SUBJECT: Forwards responses to containment sys independent design review open items transmitted in 810604 ltr to HR Denton.

Subject: Palo Verde Nuclear Generating Station
(PVNGS) Units 1, 2 and 3
Docket Nos. STN-50-528/529/530
File: 81-056-026

RESOLUTIONS OF OPEN ITEMS ADDRESSED AT
CONTAINMENT SYSTEMS IDR

Figure 1

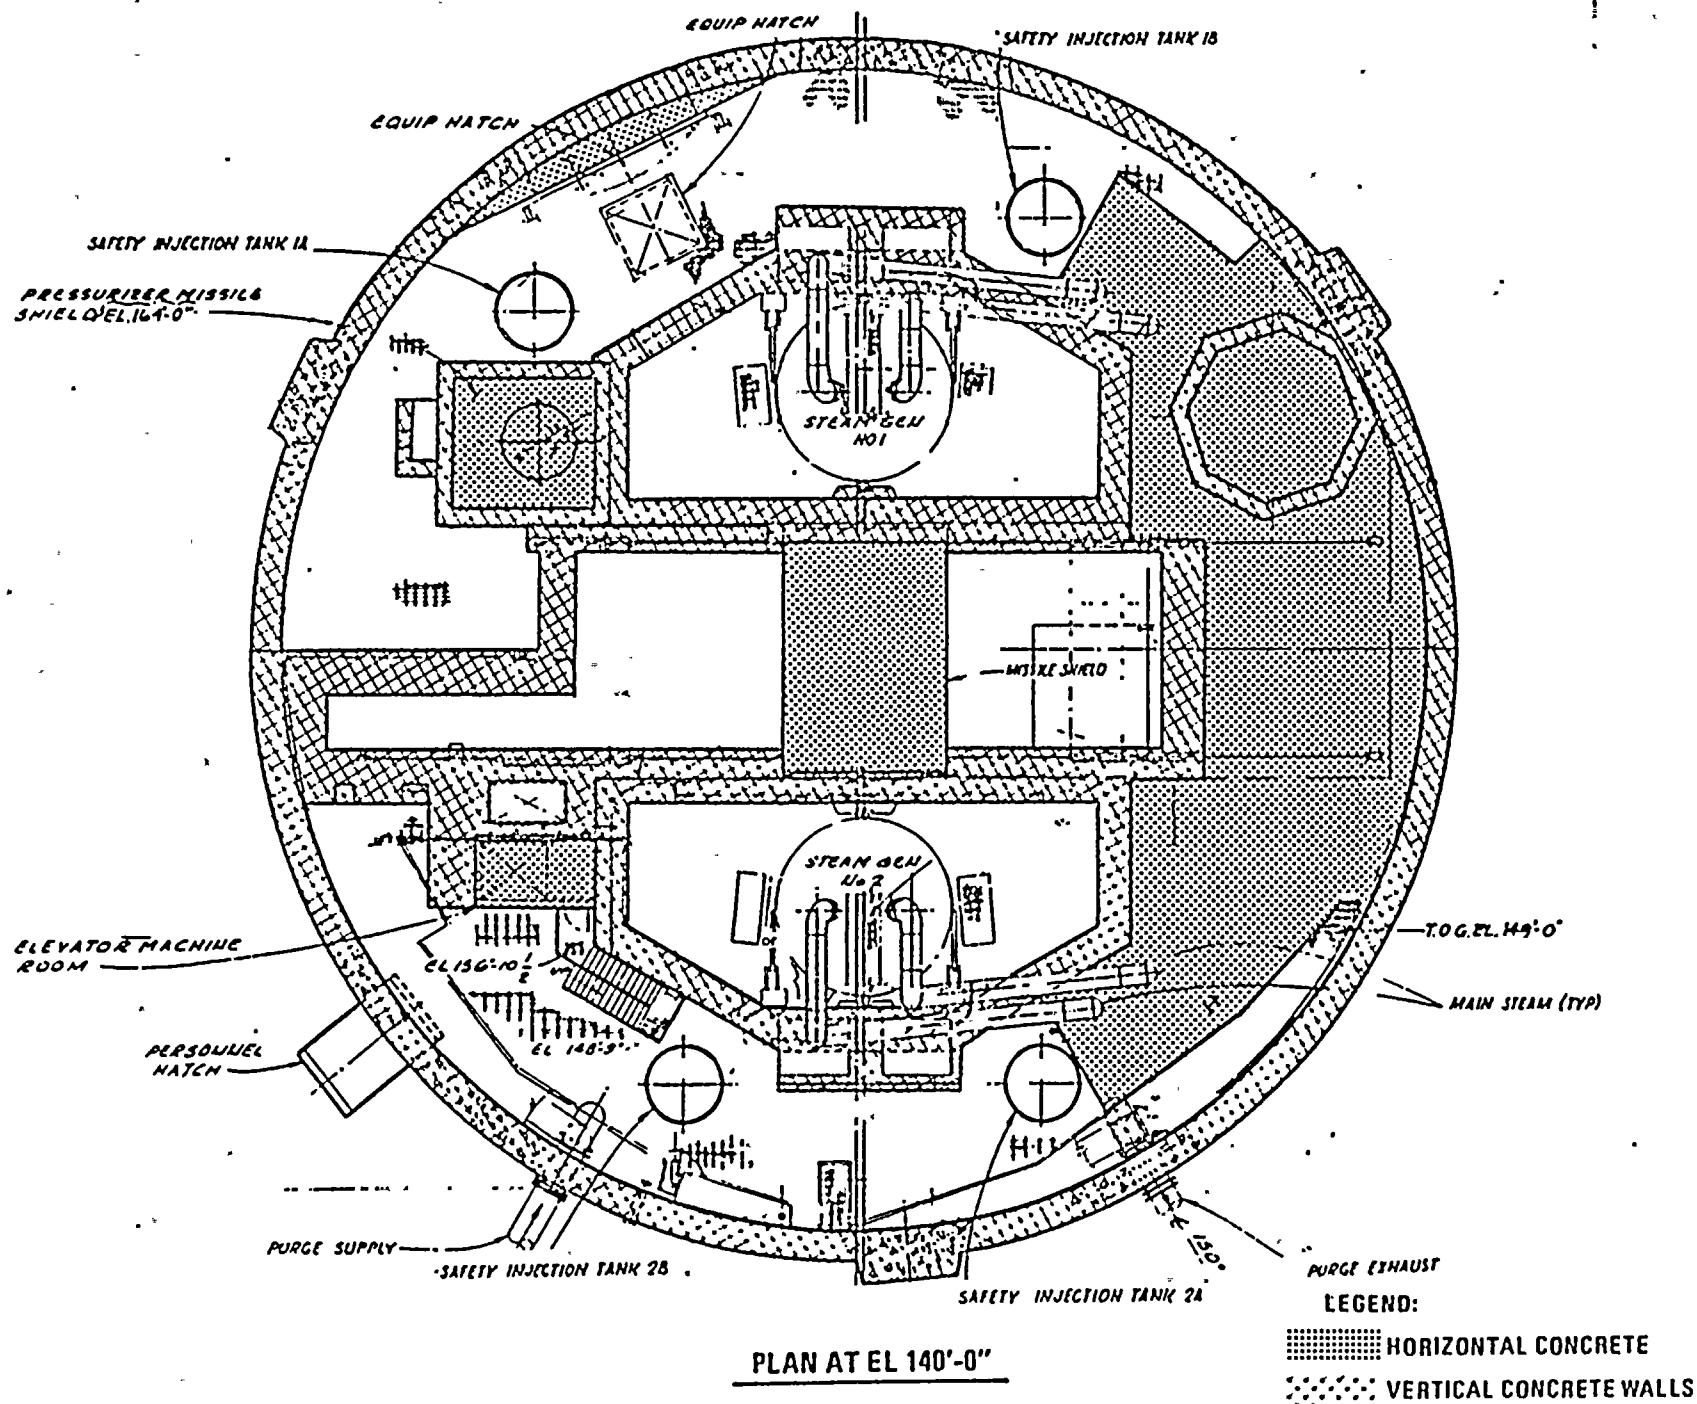
Demonstrate the adequacy of the containment design and arrangement to assure convective mixing of hydrogen throughout, and adequate cooling (p. 194).

Figures 1 through 4 show the general arrangement of the containment internal structure. Large portions of the floor slabs are grating rather than concrete. This open design promotes natural convection within the containment. To provide additional mixing capability, auxiliary spray headers have been provided beneath the 120' and 140' concrete slabs.

RECIRCULATION SUMPS
CONTAINMENT BLDG. EL. 80'
FIGURE 2-5

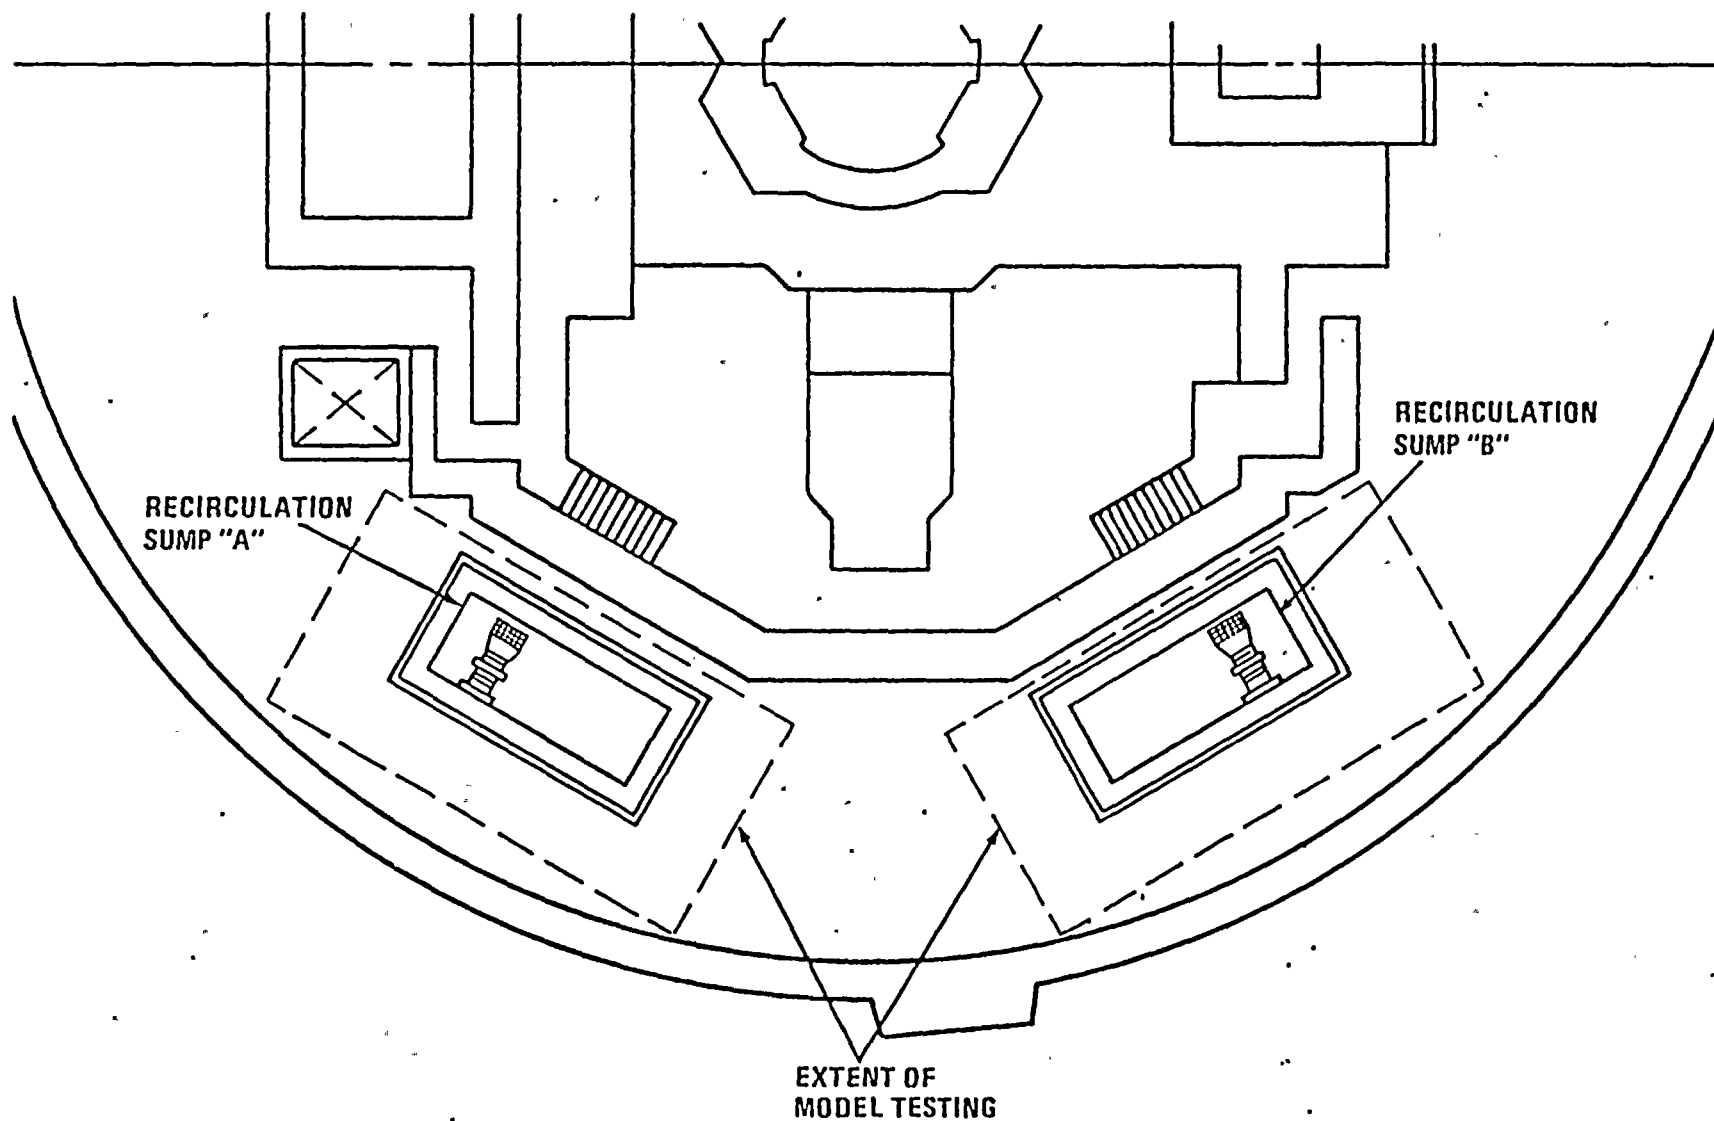
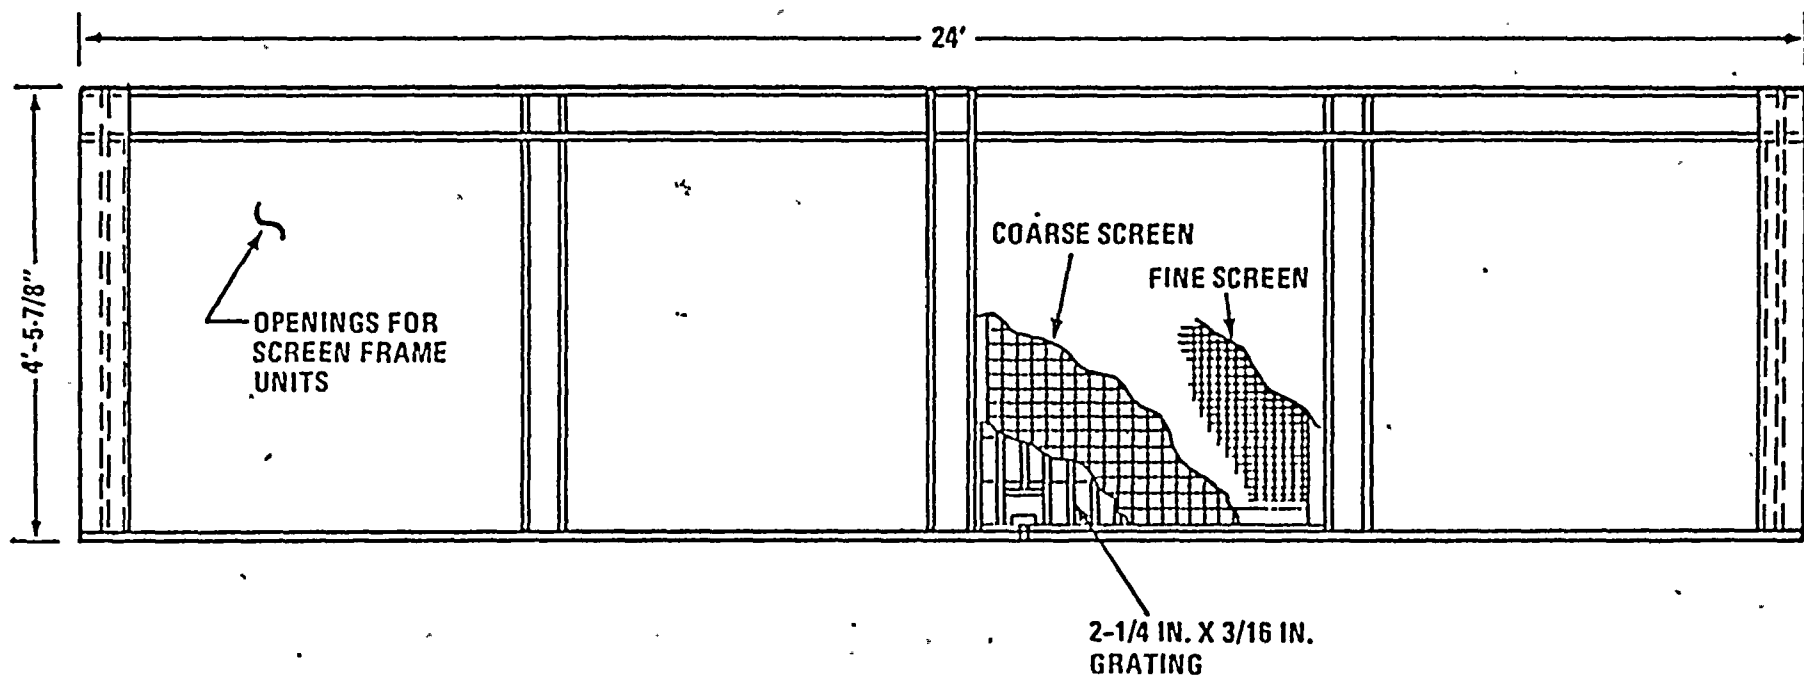
Indicate on Figure 2-5 the extent of the modeling done during the containment sump flow tests (p. 70).

Figure 2-5 has been amended to show the extent of modeling during sump flow testing and a copy provided for inclusion in the final transcript.

CONTAINMENT SUMP SCREENS AND GRATING - ELEVATION VIEW
FIGURE 2-6

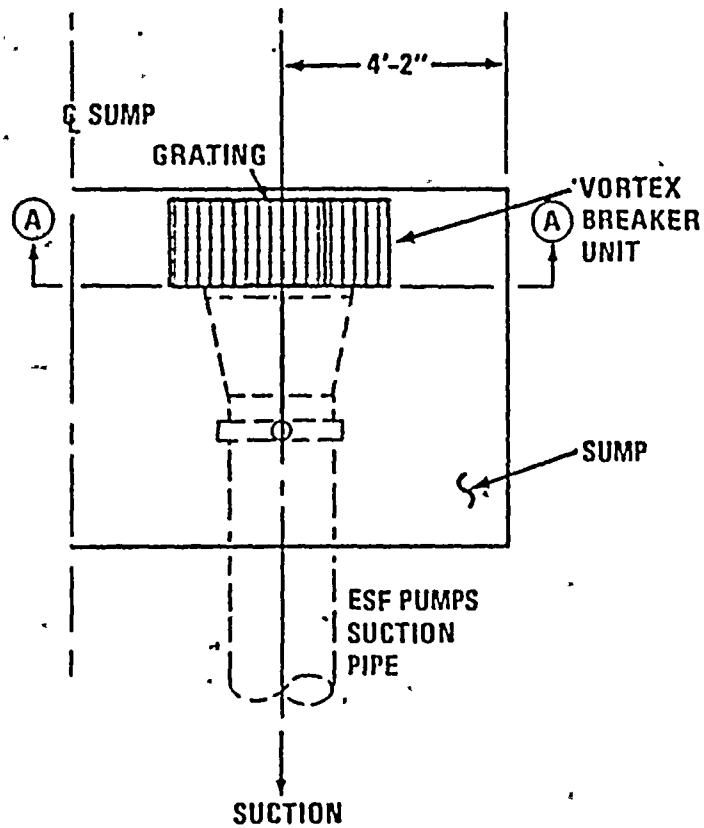
Add the height of the screen to Figure 2-6 (p. 73).

Figure 2-6 has been amended to show the height of the sump screen and a copy provided for inclusion in the final transcript.

CONTAINMENT SUMP PIPE AND VORTEX-BREAKING UNIT
PLAN VIEW (TYPICAL)
FIGURE 2-8

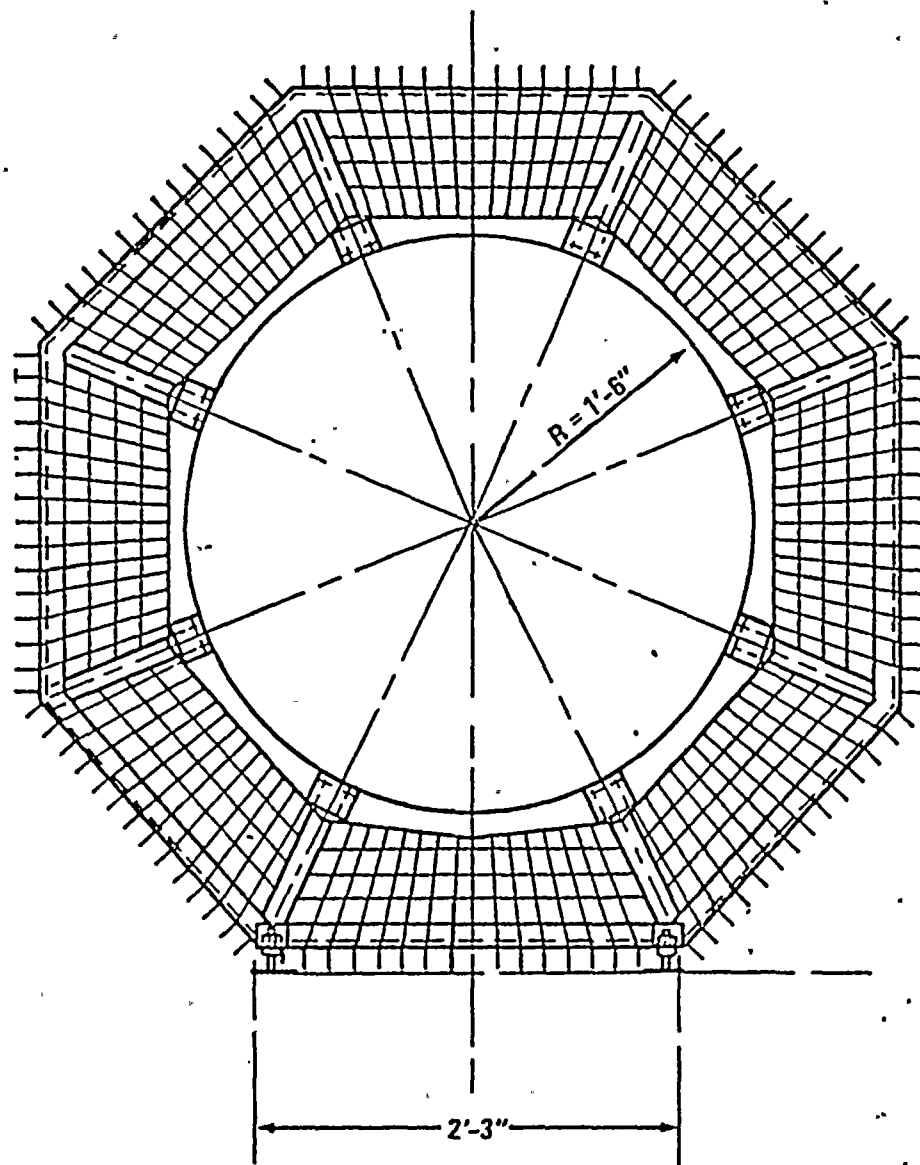
Add a section marking to Figure 2-8 as applicable (p. 66).

Figure 2-8 has been amended to show the section line and a copy provided for inclusion in the final transcript.

AUXILIARY SPRAY PATTERNS
Figure 2-11

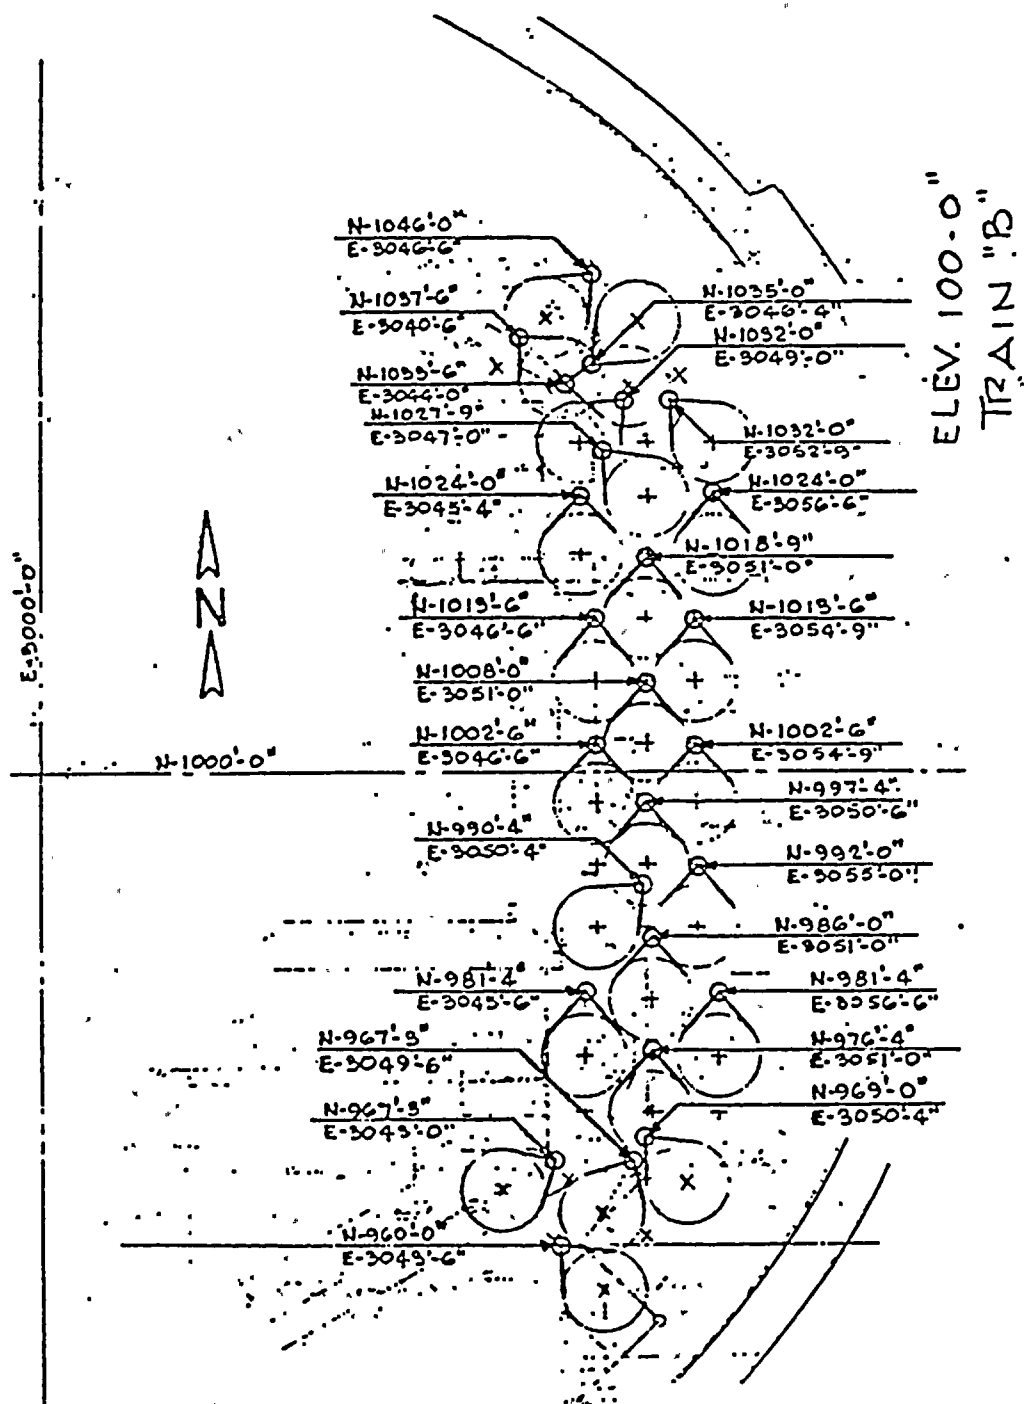
Provide drawings of auxiliary spray patterns to be appended to transcript (p. 98).

The spray patterns of the nozzles are shown on the attached new figures, Figures 2-11 thru 2-14, and copies provided for inclusion in the final transcript.

FIGURE 3-3

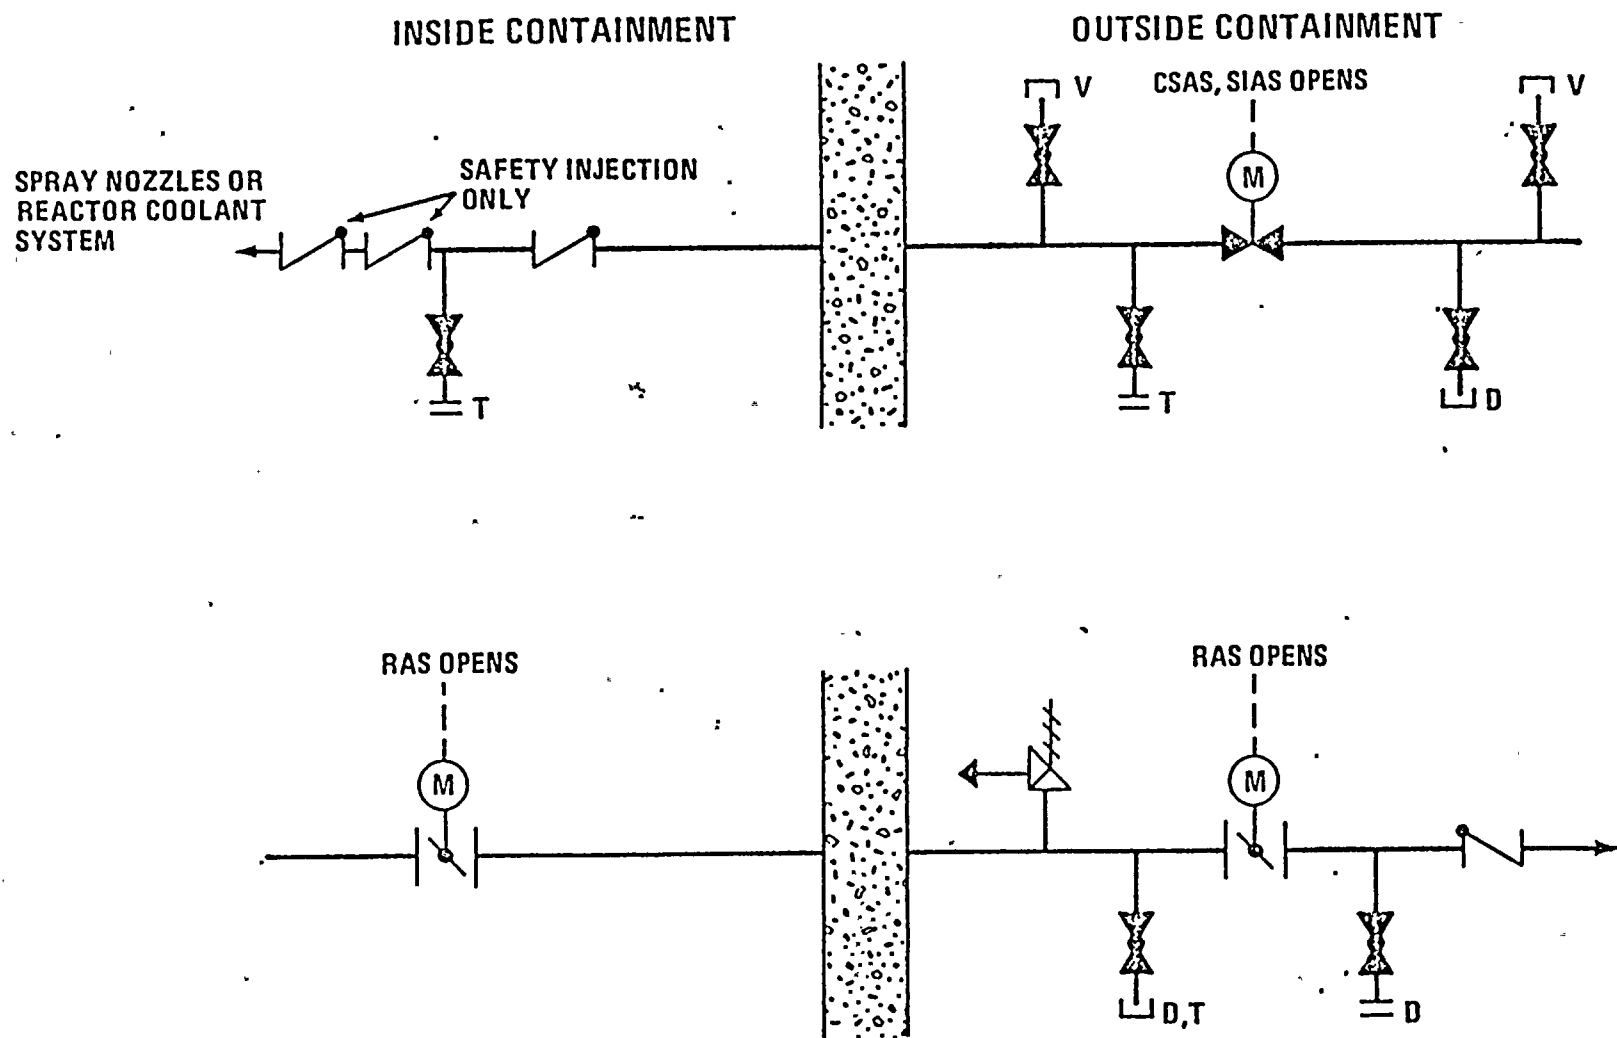
Clarify valve arrangements of Figure 3-3 (p. 112).

The typical valve arrangements shown in Figure 3-3 are correct. The arrangement with flow into the containment via the containment spray system has no in-line valves shown. The arrangement for high or low pressure safety injection has two additional in-line check valves downstream of the check valve shown. Figure 3-3 has been amended to show these valves with the note "Safety Injection only". An additional note has been added to signify containment spray nozzles or reactor coolant system. In addition, Figure 3-1 has been revised to show a valve downstream of the drain and test connection. Updated versions of Figure 3-1 and 3-3 have been provided for inclusion in the final transcript.
